Location of Leased Premise **CALANDRA LOOKOUT** **MONTEREY COUNTY**
Agency Department of Forestry & Fire Protection **Real Property** #429

COMMUNICATIONS VAULT LEASE

AMENDMENT NO. One

Subject: CDF Radio Vault Space Application (TD-312) Modification
County of Monterey - L-0058
Calandra Lookout, Monterey County
CDF-VLT LCDF001154

PROPOSED TOWER ELEVATIONS

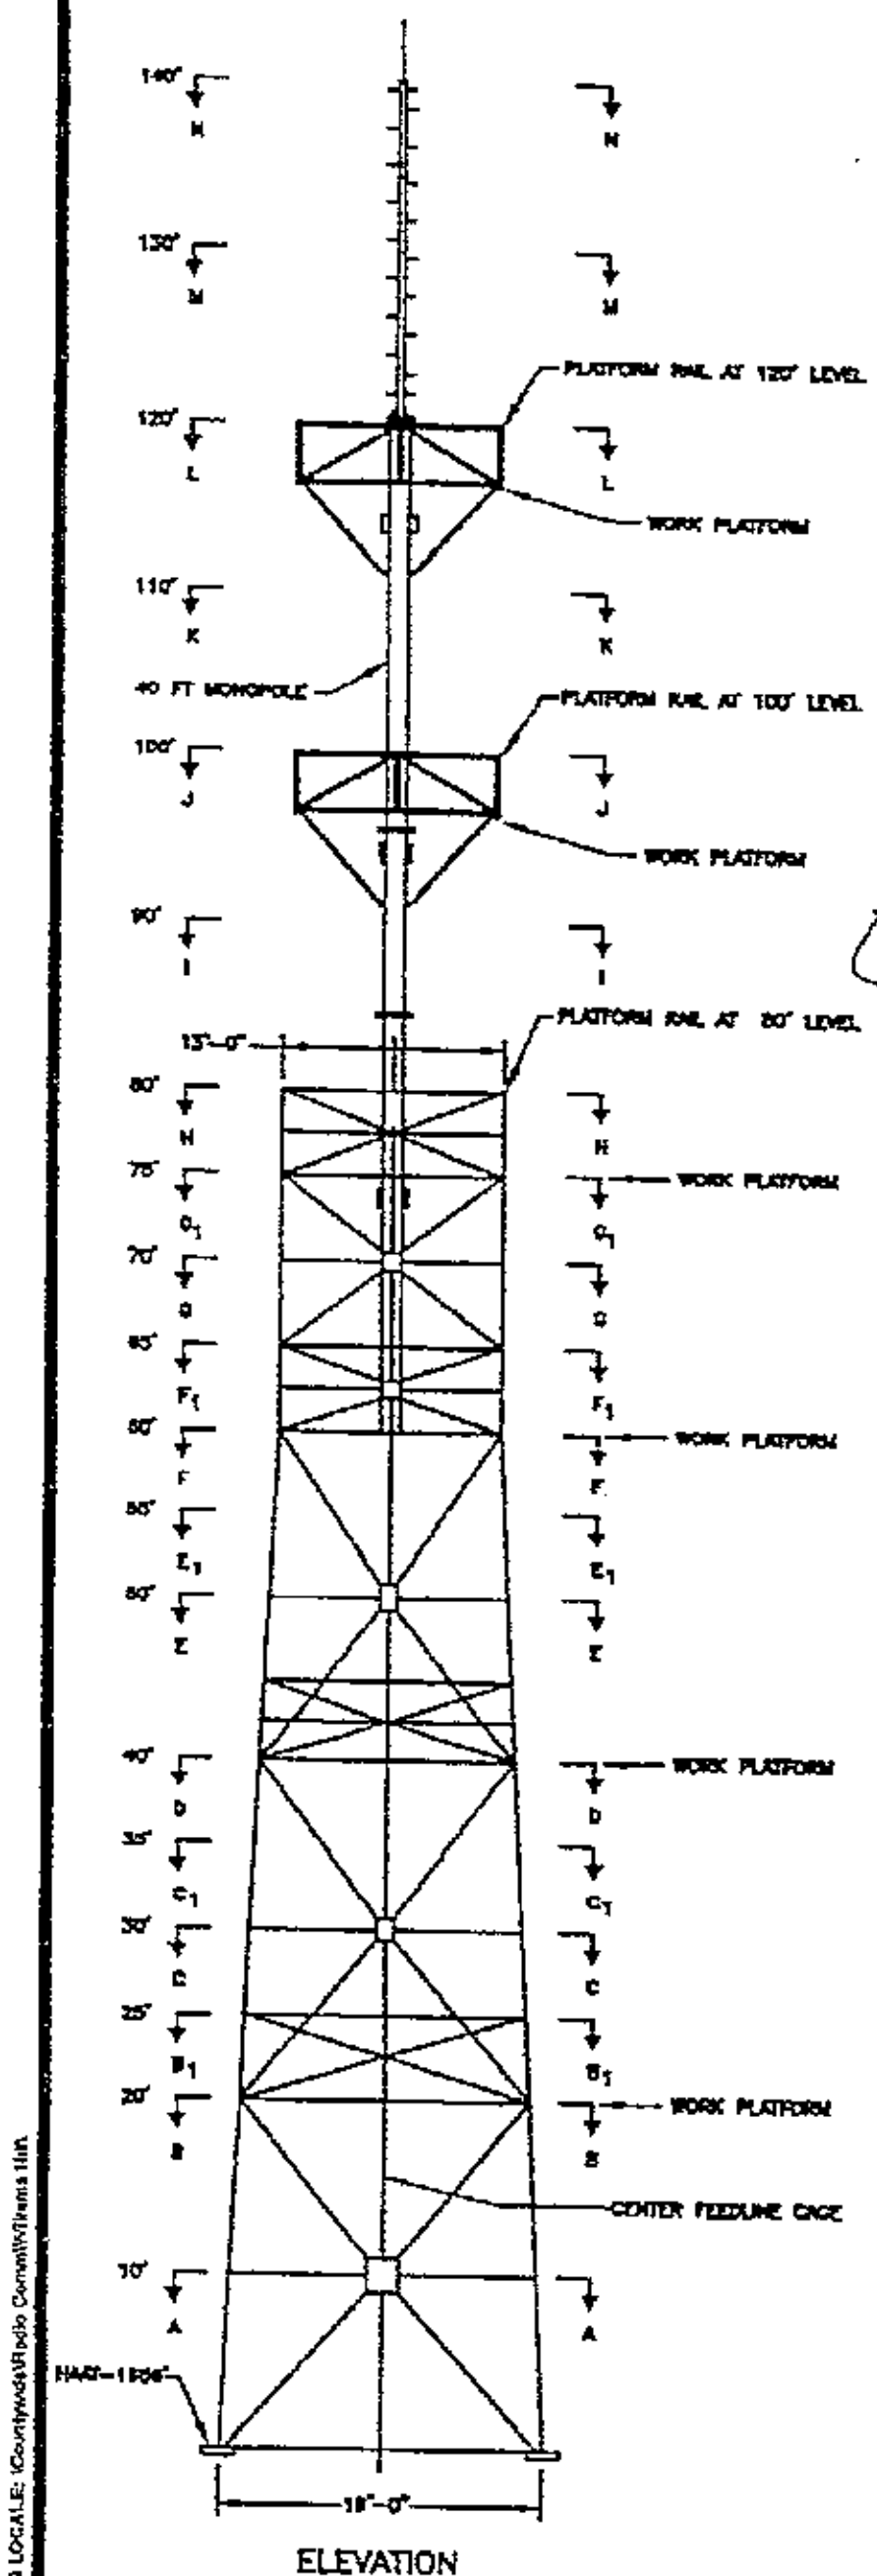
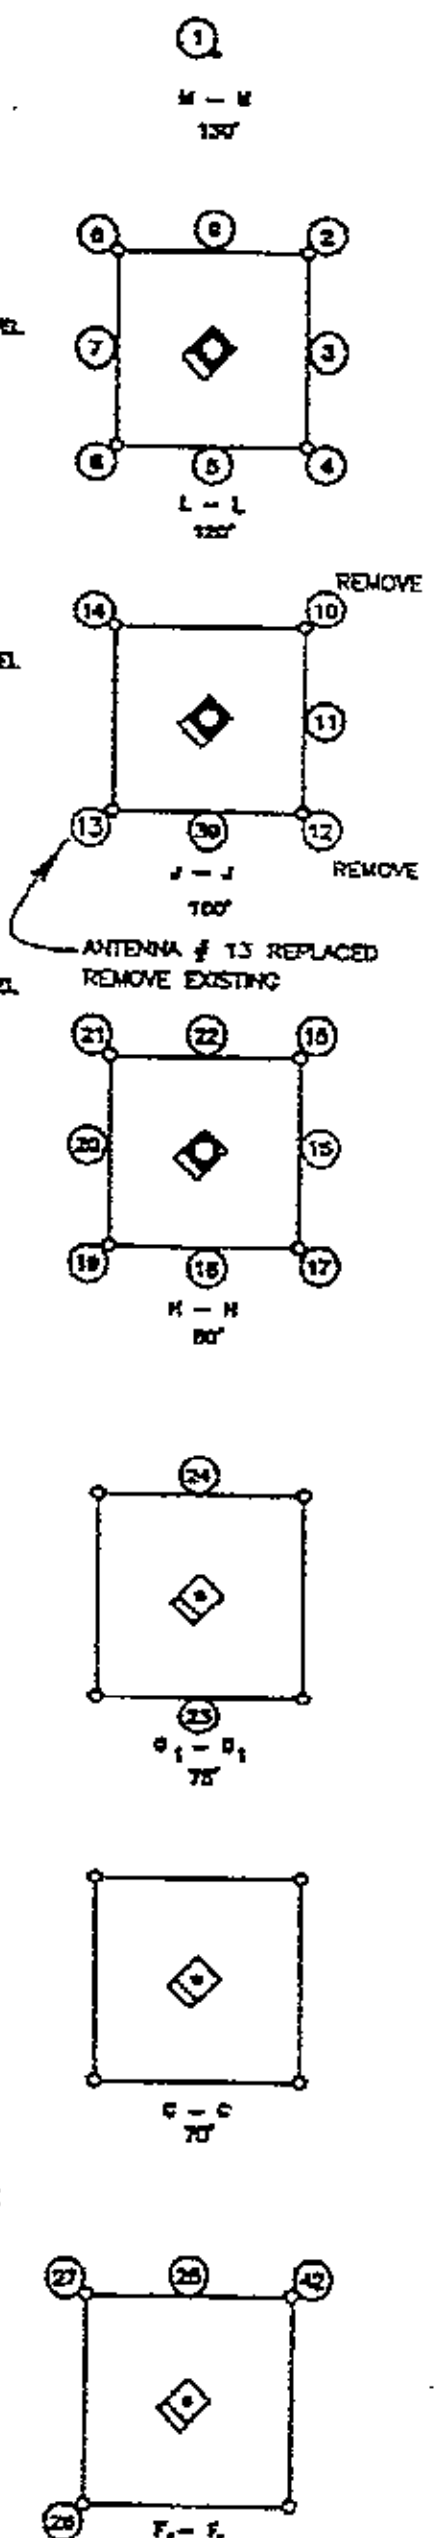
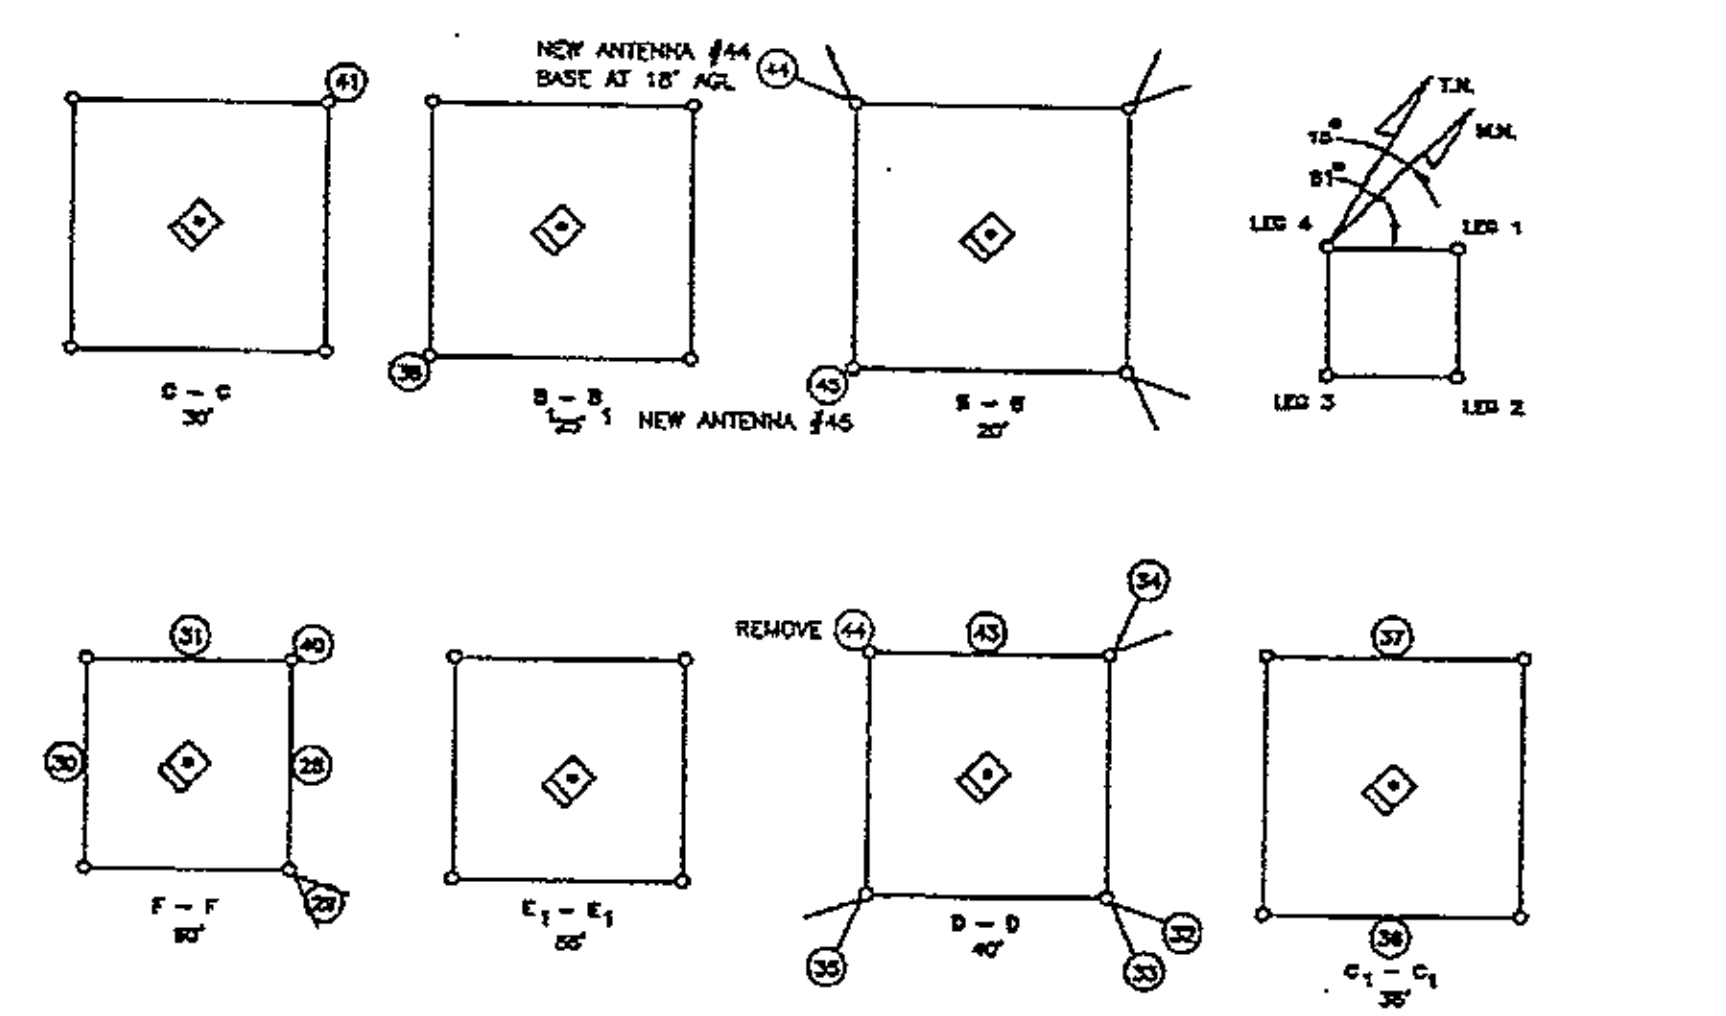
Antenna #	Make and Model	Length or M/W dish size	Gain (dBd) (dBi for M/W)	Azimuth (relative to true north)	*Height desired (feet)	Existing (E) Removing (R) New (N)	Description
42	Andrew UHP6-59WB (Position 65-1)	6'	39.3dBi	339.163	65.0'	(E)	MICROWAVE TO KC
41	Andrew PAR6-65B (Position 30-1)	6'	38.8dBi	339.163	30.0'	(E)	MICROWAVE TO KC
43	Sinclair SD235-HF2PALDF (DO2) (Position 40-3.5)	17'	5.5dBd	360	40.0'	(E)	OVERLAY Tx
10	~~Celwave AP881208 (Position 100-1)~~	~~24'~~	~~7.5dBd~~	~~330~~	~~100.0~~	(R)	~~800MHz MDT~~
12	~~Celwave AP881208 (Position 100-2)~~	~~24'~~	~~7.5dBd~~	~~330~~	~~100.0'~~	(R)	~~800MHz MDT~~
13	~~Celwave AP881208 (Position 100-3)~~	~~24'~~	~~7.5dBd~~	~~330~~	~~100.0'~~	(R)	~~800MHz MDT~~
14	Sinclair SRL310C8 (Position 100-4)	10'	11dBd	330	100.0'	(E)	MED-CHNL
16	~~DBSpectra DS1F06F36U-D (Position 80-1)~~	~~22'~~	~~6dBd~~	~~360~~ 281	~~80'~~	(R)	~~VHF MULTICST~~ 201
44	~~DBSpectra DS1F06F36U-D (Position 40-1)~~	~~22'~~	~~6dBd~~	~~360~~	~~40'~~	(R)	~~VHF MULTICST~~

16	DBSpectra DS7E12F36U-D (Position 80-4)	24'	12dBd	360	80'	(N)	PROPOSED Rx 700MHz NGEN
44	Andrew DB810E-PS (Replaces Antenna #44 at different mount height) (Position 18-4)	14.7'	12dBd	360	18'	(N)	PROPOSED Tx 700MHz NGEN
13	Telewave ANT850F6 (Replaces Antenna #13 at same height) (Position 100-3)	4.7'	6dBd	360	100'	(N)	PROPOSED Rx 800MHz MST
45	Telewave ANT850F6 (Position 20-3)	4.7'	6dBd	360	20'	(N)	PROPOSED Tx 800MHz MST

REV.	DATE	DESCRIPTION
-	4/24/12	ISSUE FOR SUBMITTAL
1	10/12/12	ADDED FREQ. TO DIGITAL
2	8/15/15	CHANGED MULTICAST SYSTEM FROM VHF TO 700MHz MULTICAST

ANALOG OVERLAY SYSTEM MODIFICATIONS

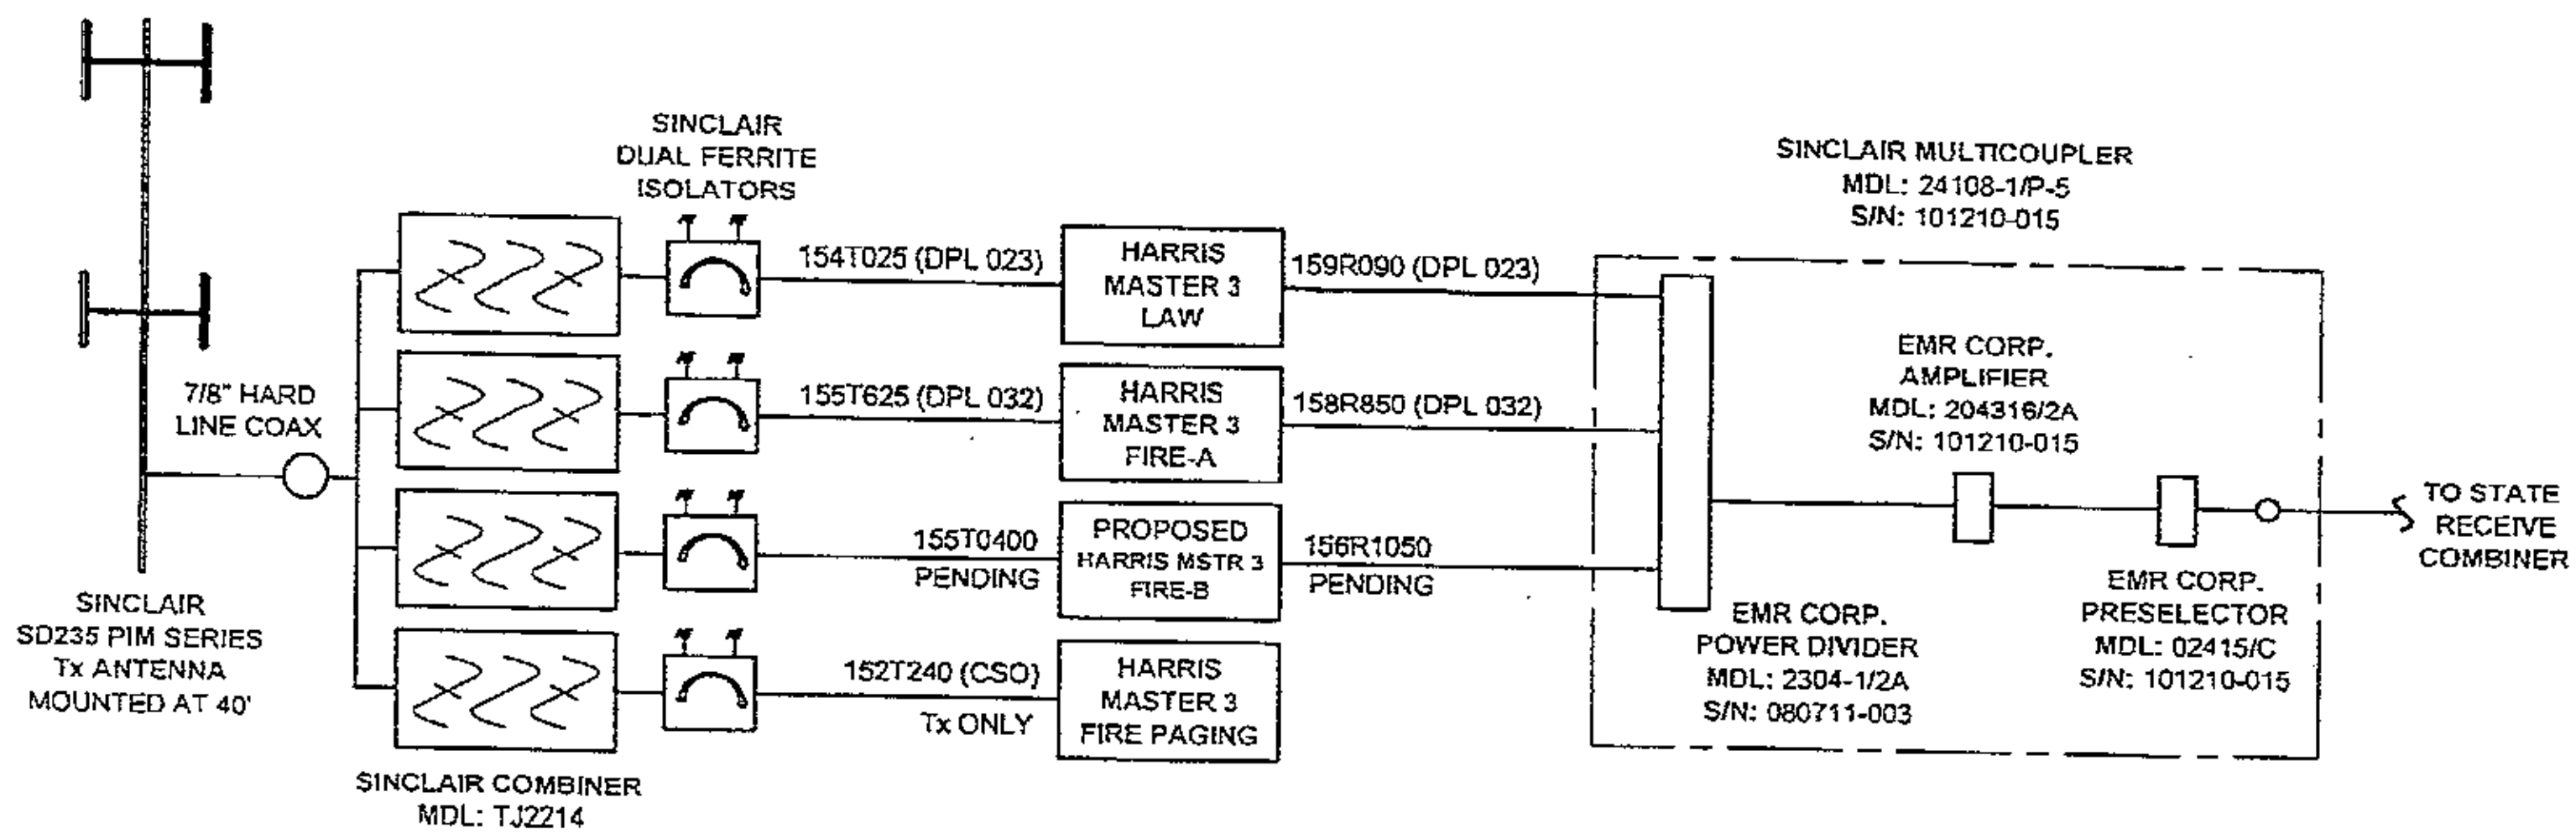
ALL EQUIPMENT SHOWN
HERE IN RACK #13

REV.	DATE	DESCRIPTION
-	4/24/12	ISSUE FOR SUBMITTAL
1	10/12/12	ADDED FREQ. TO DIGITAL
2	0/15/15	CHANGED MULTICAST SYSTEM FROM VHF TO 700MHz MULTICAST

CABLING EXTENSION
EXISTING EQUIPMENT
MED-5

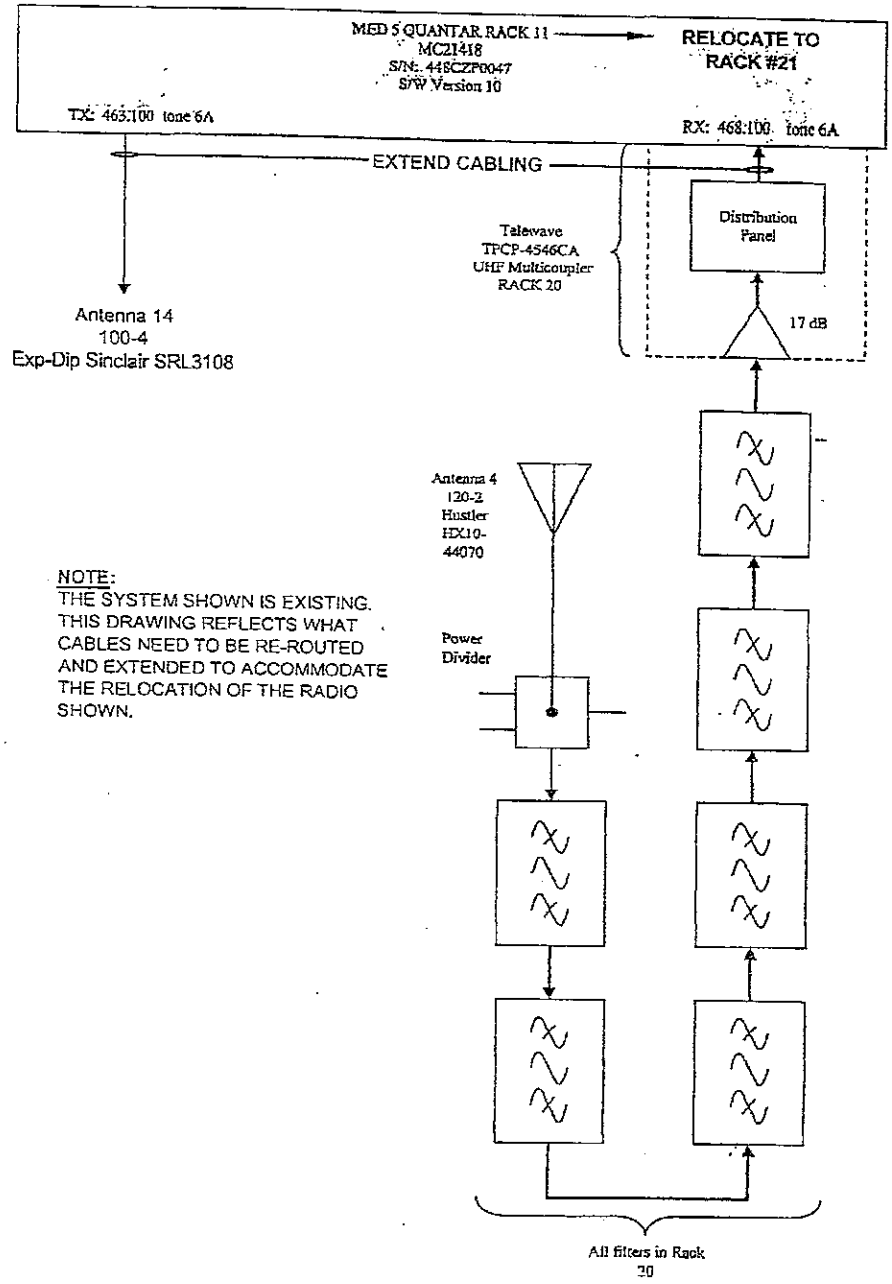
NOTE:
THE SYSTEM SHOWN IS EXISTING.
THIS DRAWING REFLECTS WHAT CABLES NEED TO BE RE-ROUTED AND EXTENDED TO ACCOMMODATE THE RELOCATION OF THE RADIO SHOWN.

PROPOSED UHF LINK TO TABLE MOUNTAIN

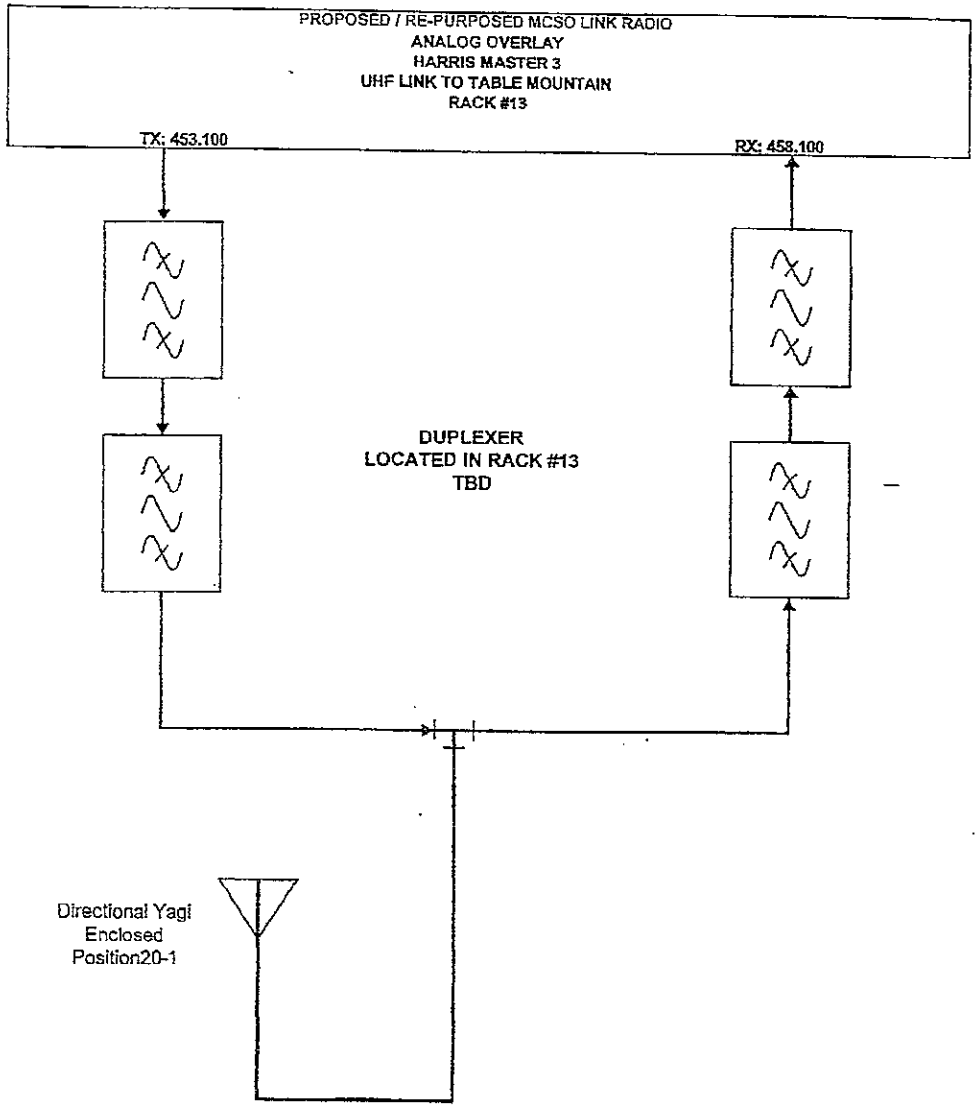
Replace/consolidate VHF Multicast equipment in Rack 11 and 12 with 700 Mhz Multicast (to occupy only Rack 12). Backfill Rack 11 with new County MST 800Mhz. Install UPS near existing State battery bank. Add UHF link and single VHF analog channel.
